PROJECT **Butler Tech and Career Development Schools 2023 Paving Maintenance Project**

ADDENDUM NO. 1

RE: **2023 Campus Paving Maintenance for
Butler Tech and Career Development Schools**
3603 Hamilton Middletown Road
Hamilton, Ohio 45011

C101

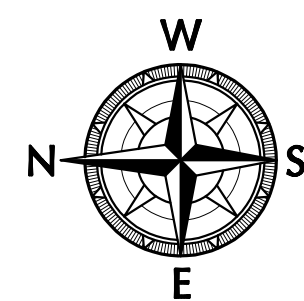
1. At the Fairfield Campus (DRL), the existing catch basins do not have an upper concrete collar separate from the main body of the concrete structure (Note #6, sheet C101). Rather, the entire catch basin is in one concrete piece. How should these be addressed?

1. Remove sheet C101 and **replace with revised sheet C101**, attached to this Addendum.
 - 1.1. Clarify scope related to note #6, existing catch basins.

- 1.2. Add General Note #4: Provide full depth crack seal across entire campus parking lot and re-stripe affected areas as required – base bid.
2. Remove sheet C103 and **replace with revised sheet C103**, attached to this Addendum.

RESPONSE: Work described in note #6, sheet C101 shall be considered Alternate #01. See added specification section attached to this addendum. Contractor shall completely remove existing concrete catch basin and provide new full depth concrete catch basin to match existing. Contractor shall field verify existing pipe inverts and sizes and provide new units to match. Provide shop drawings for Architect's review.

6. CONTRACTOR SHALL COMPLETELY REMOVE EXISTING CONCRETE CATCH BASIN AND PROVIDE NEW FULL DEPTH CONCRETE CATCH BASIN TO MATCH EXISTING. CONTRACTOR SHALL FIELD VERIFY EXISTING PIPE INVERTS AND SIZES AND PROVIDE NEW UNITS TO MATCH. PROVIDE SHOP DRAWINGS FOR ARCHITECT'S REVIEW.

Project Number 06398.82
Drawing Scale AS NOTED
Sheet Number **C103**
File Number 06398 82

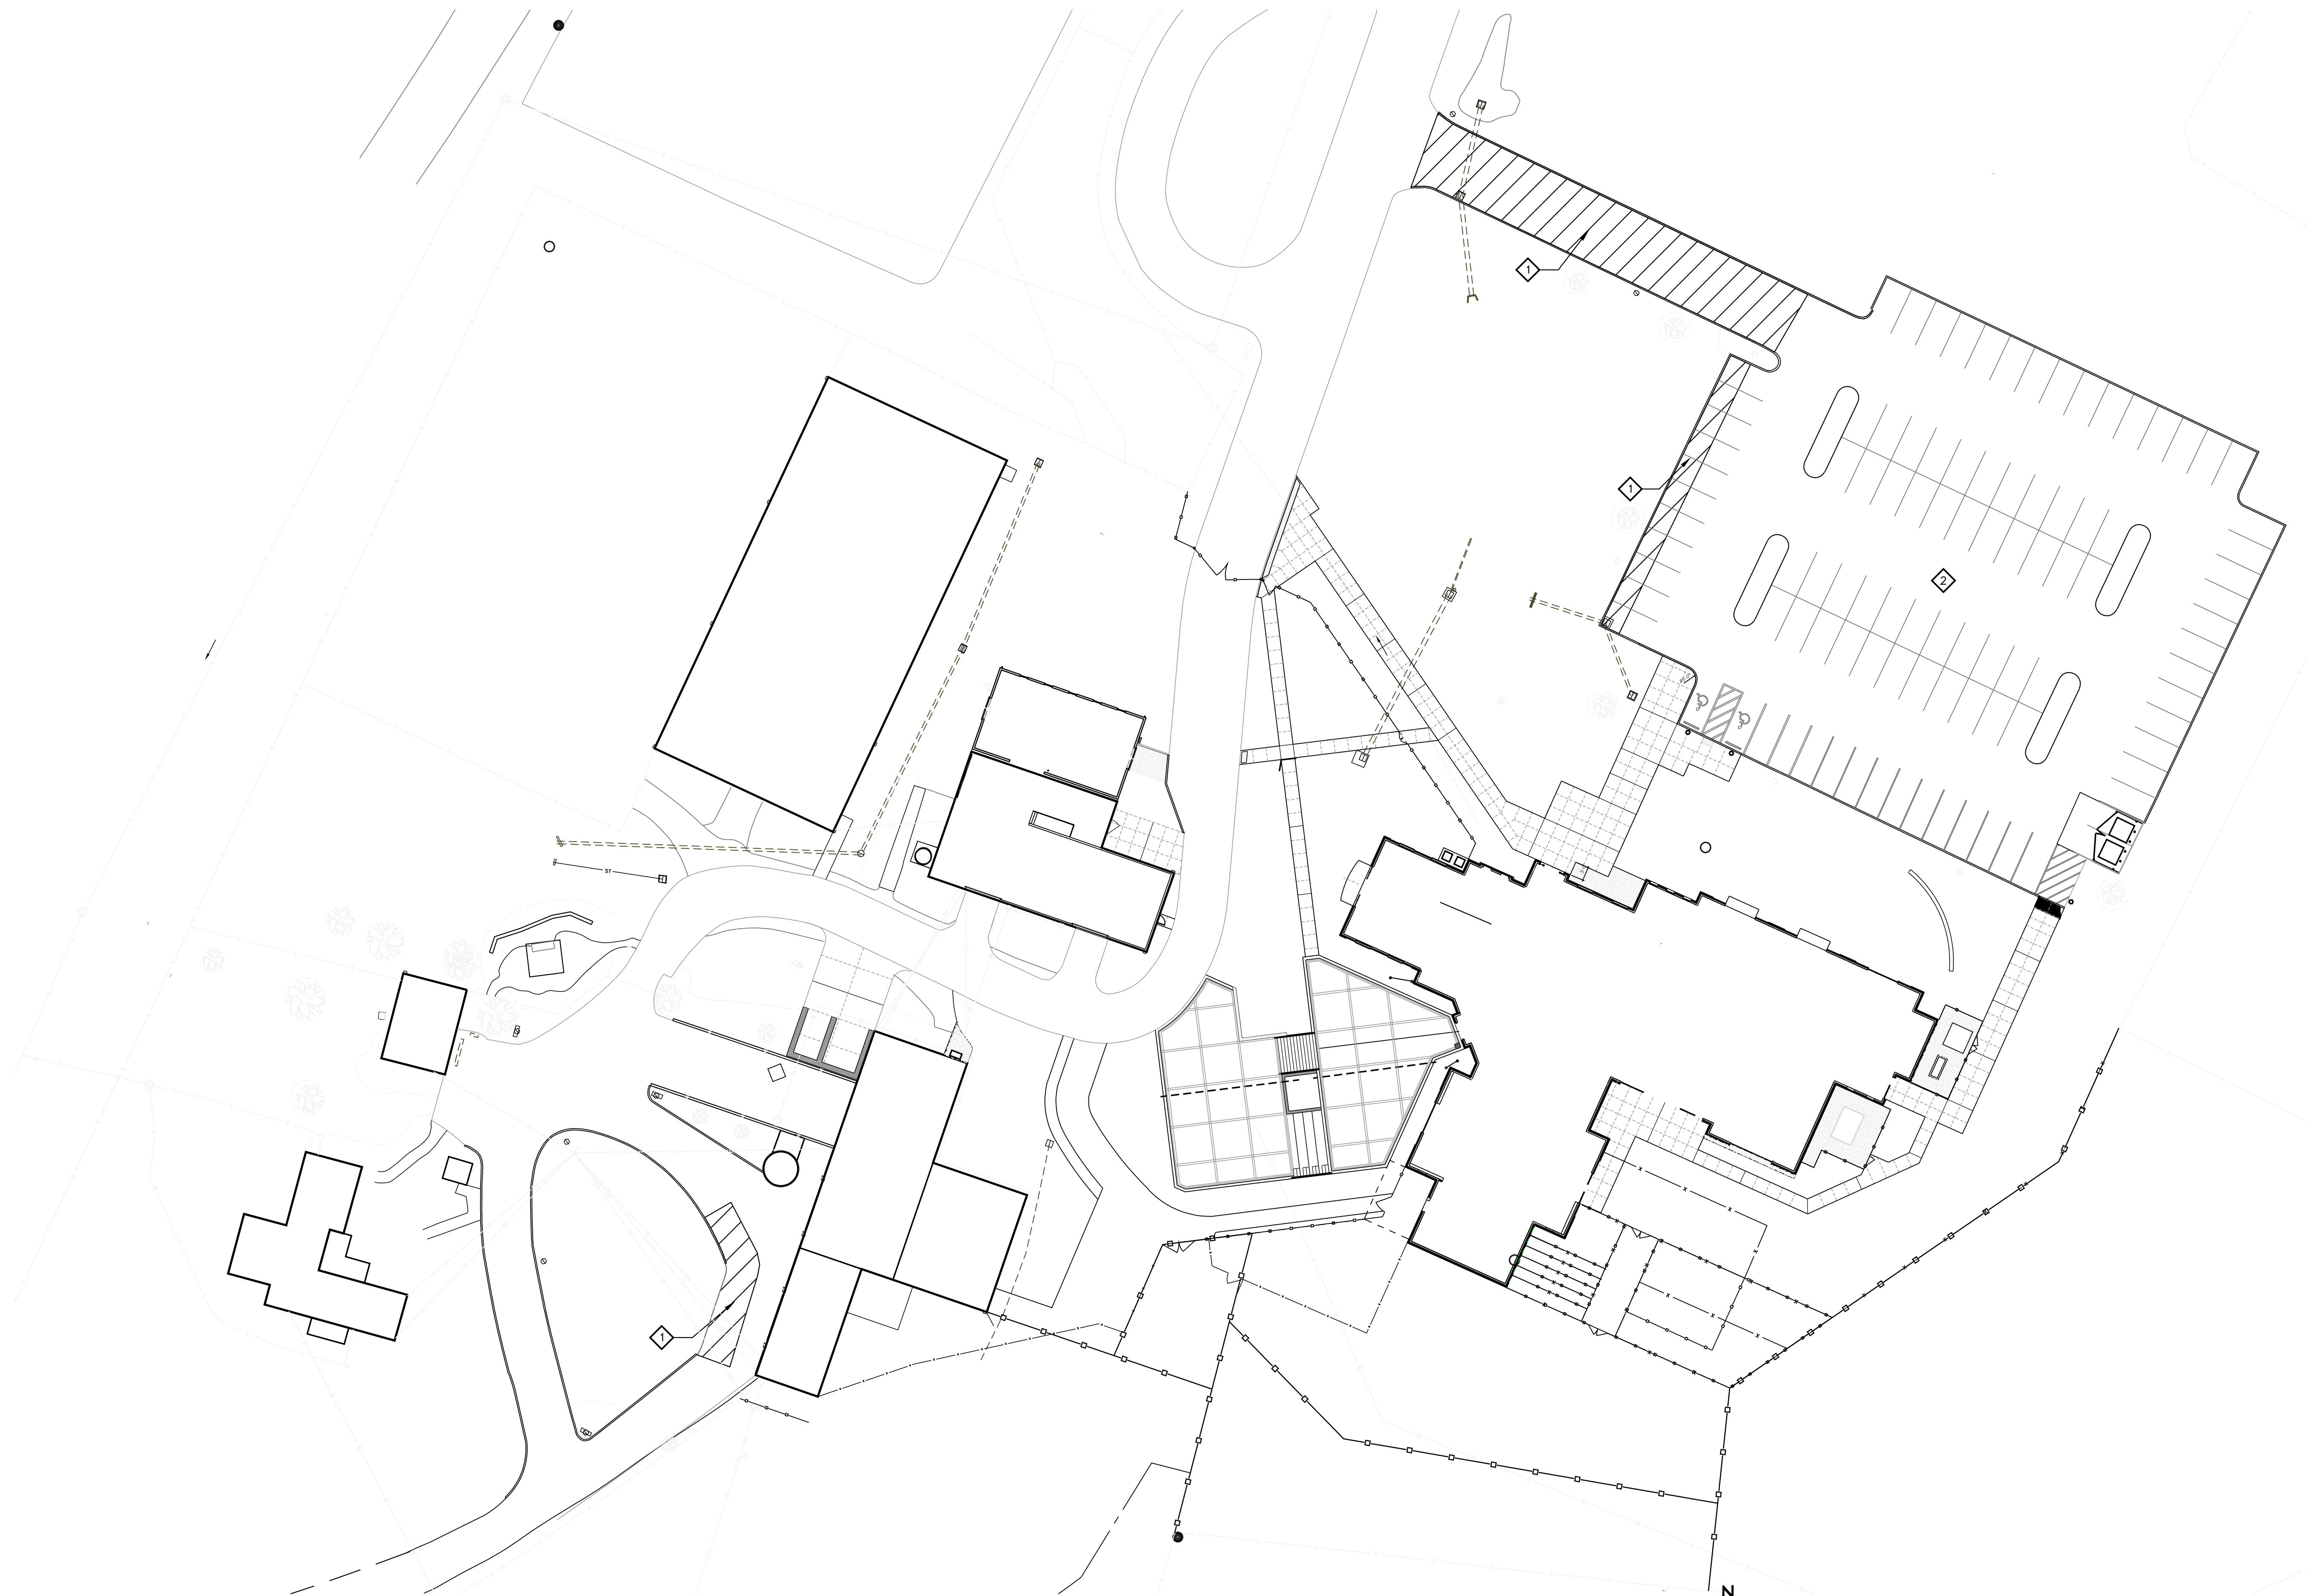
- 2.1. Add General Note #6: Provide full depth crack seal across entire campus parking lot and re-stripe affected areas as required – base bid.
3. Remove sheet C104 and **replace with revised sheet C104**, attached to this Addendum.

Project Number 06398.82
Drawing Scale SITE PLAN
Sheet Number C104
File Number 06398 82

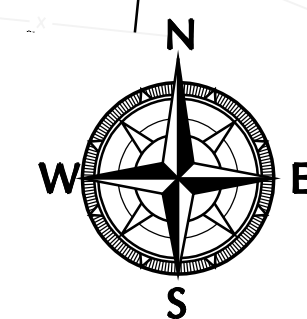
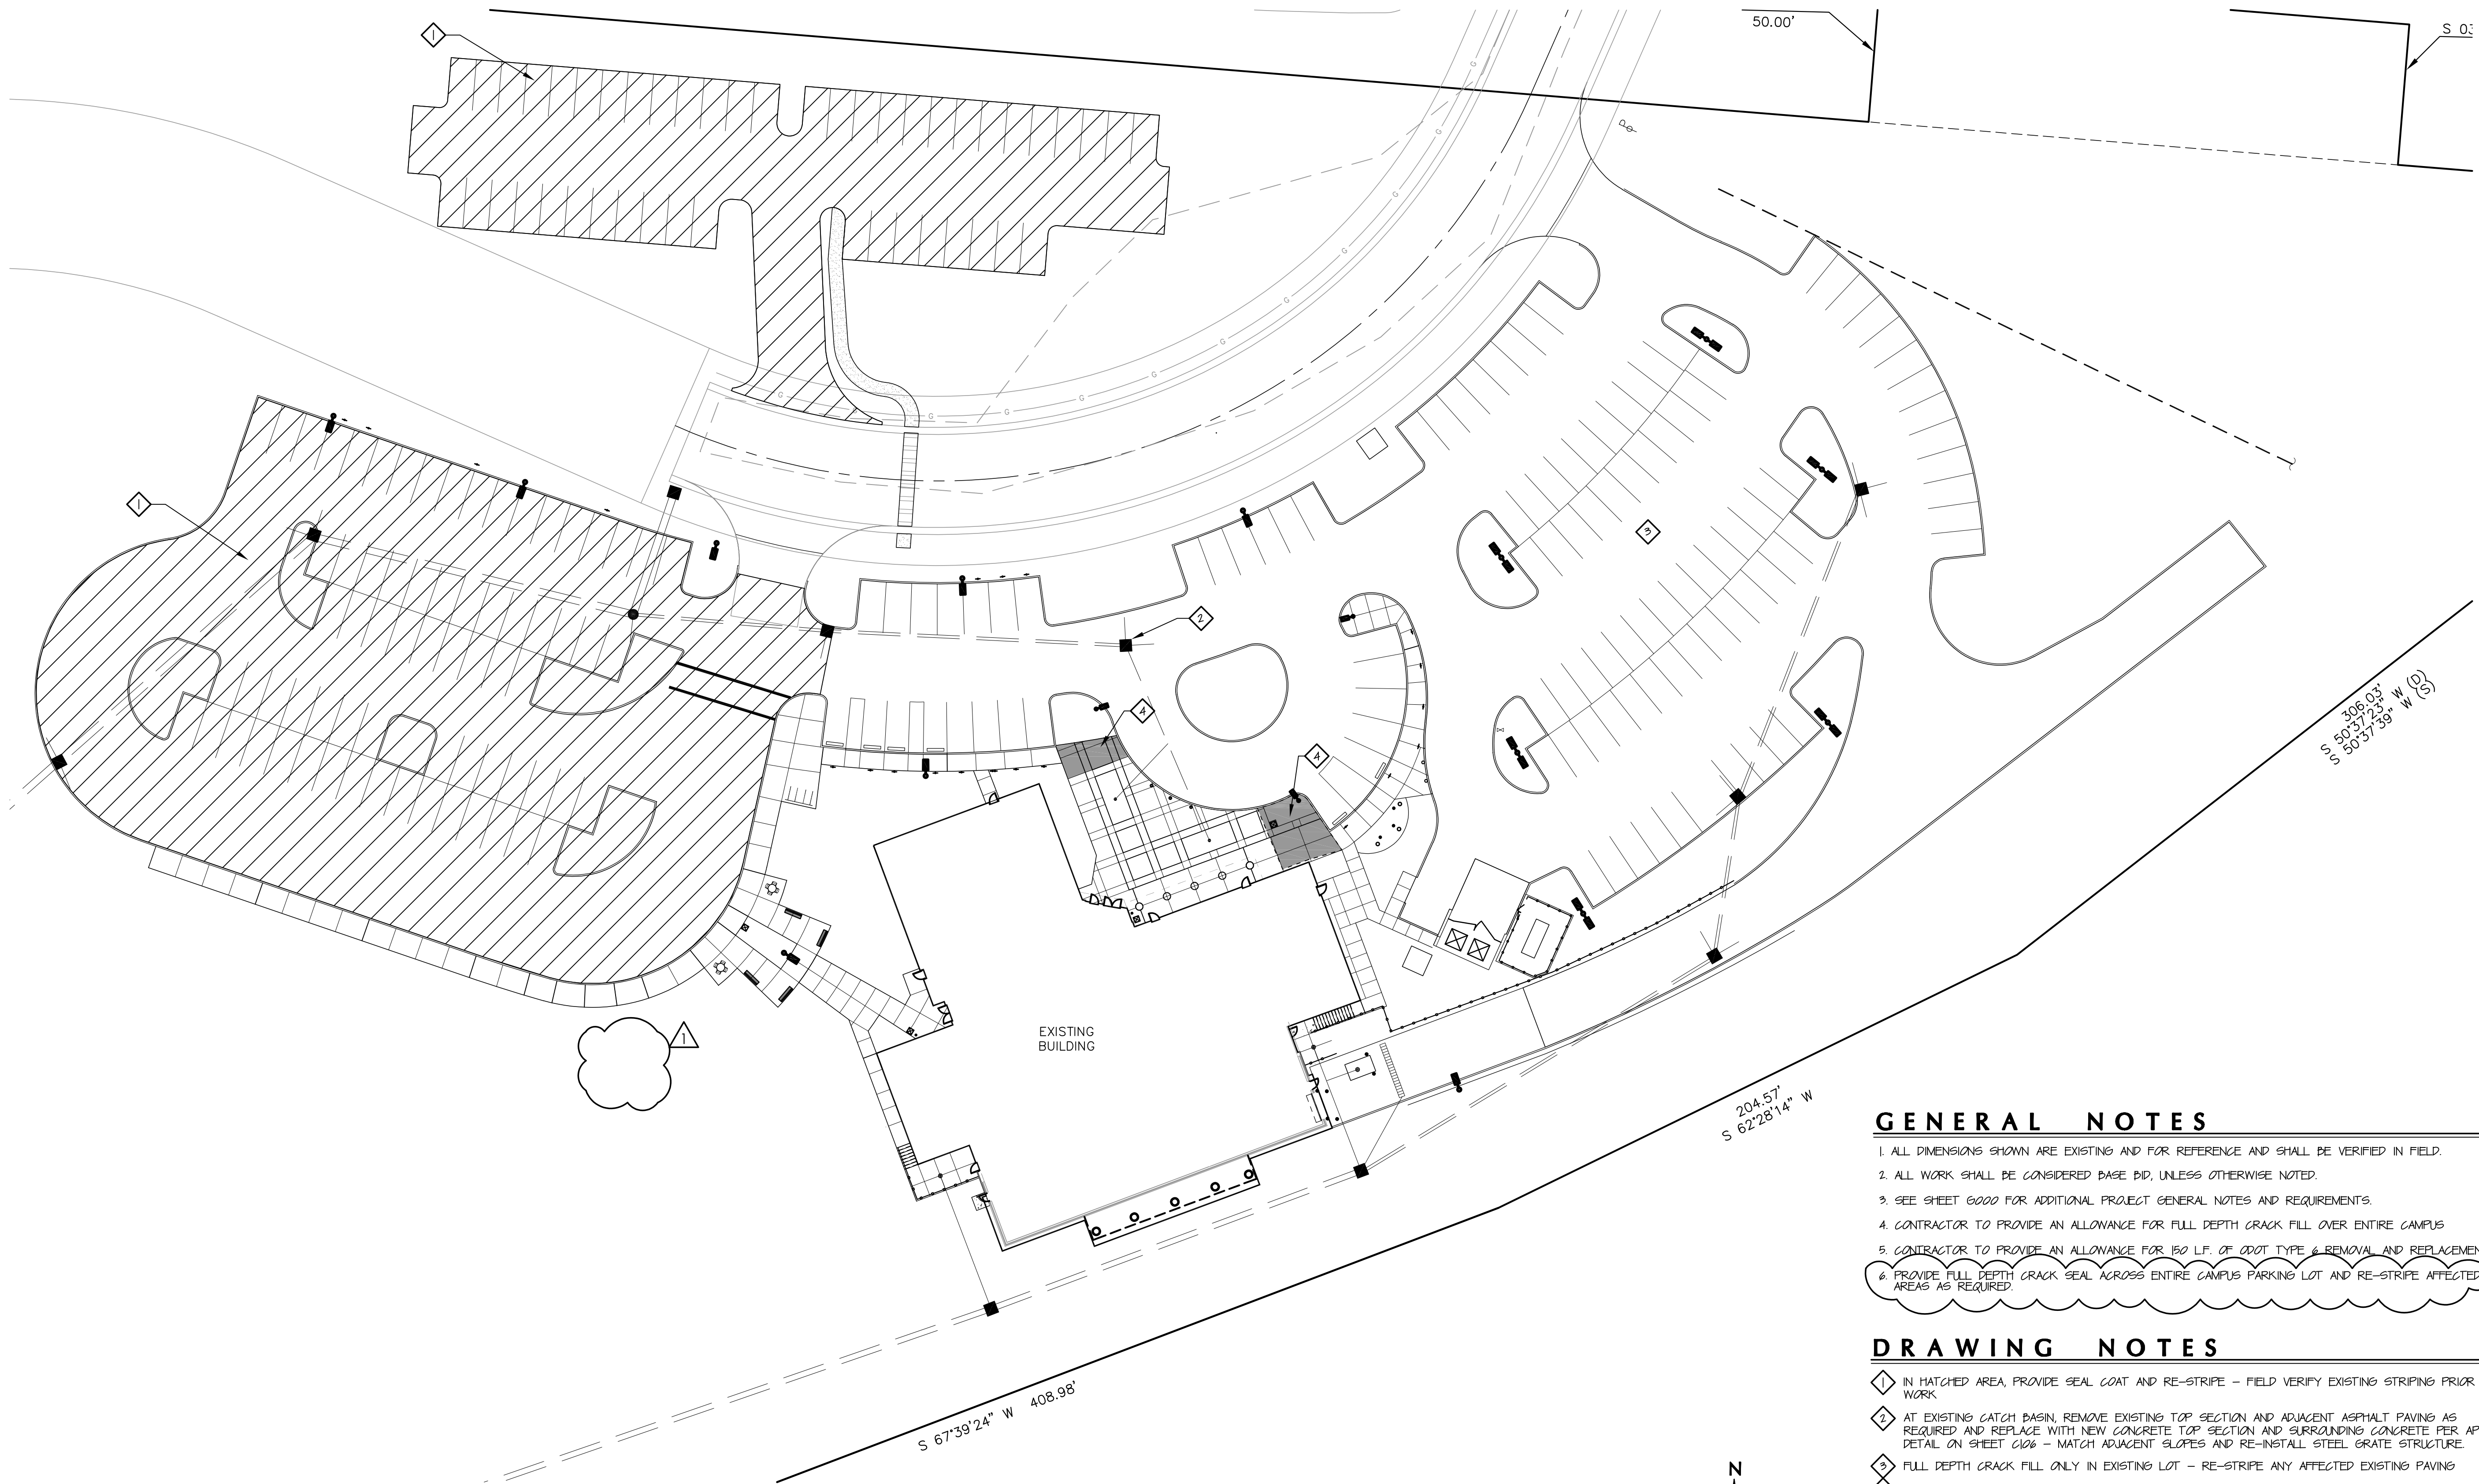
- 3.1. Add General Note #4: Provide full depth crack seal across entire campus parking lot and re-stripe affected areas as required – base bid.
4. Remove sheet C105 and **replace with revised sheet C105**, attached to this Addendum.

1. ALL DIMENSIONS SHOWN ARE EXISTING AND FOR REFERENCE AND SHALL BE VERIFIED IN FIELD.
2. ALL WORK SHALL BE CONSIDERED BASE BID, UNLESS OTHERWISE NOTED.
3. SEE SHEET 0000 FOR ADDITIONAL PROJECT GENERAL NOTES AND REQUIREMENTS.
4. PROVIDE FULL DEPTH CRACK SEAL ACROSS ENTIRE CAMPUS PARKING LOT AND RE-STRIPE AFFECTED AREAS AS REQUIRED.

Project Number 06398.82
Drawing Scale AS NOTED
Sheet Number **C105**
File Number 06398 82

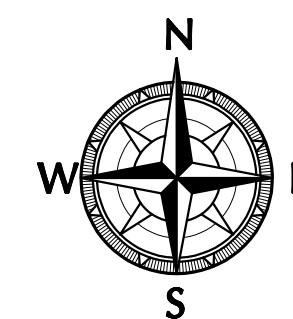
- 4.1. Revise General Note #4 to read as follows: Provide full depth crack seal across entire campus parking lot and re-stripe affected areas as required – base bid.

- 4.2. Remove Note #4 on the Southwest parking lot, concrete sidewalk paving. See plans.

1. ALL DIMENSIONS SHOWN ARE EXISTING AND FOR REFERENCE AND SHALL BE VERIFIED IN FIELD.
2. ALL WORK SHALL BE CONSIDERED BASE BID, UNLESS OTHERWISE NOTED.
3. SEE SHEET 6000 FOR ADDITIONAL PROJECT GENERAL NOTES AND REQUIREMENTS.
4. CONTRACTOR TO PROVIDE AN ALLOWANCE FOR FULL DEPTH CRACK FILL OVER ENTIRE CAMPUS
5. CONTRACTOR TO PROVIDE AN ALLOWANCE FOR 150 LF. OF 000T TYPE 6 REMOVAL AND REPLACEMENT
6. PROVIDE FULL DEPTH CRACK SEAL ACROSS ENTIRE CAMPUS PARKING LOT AND RE-STRIPE AFFECTED AREAS AS REQUIRED.
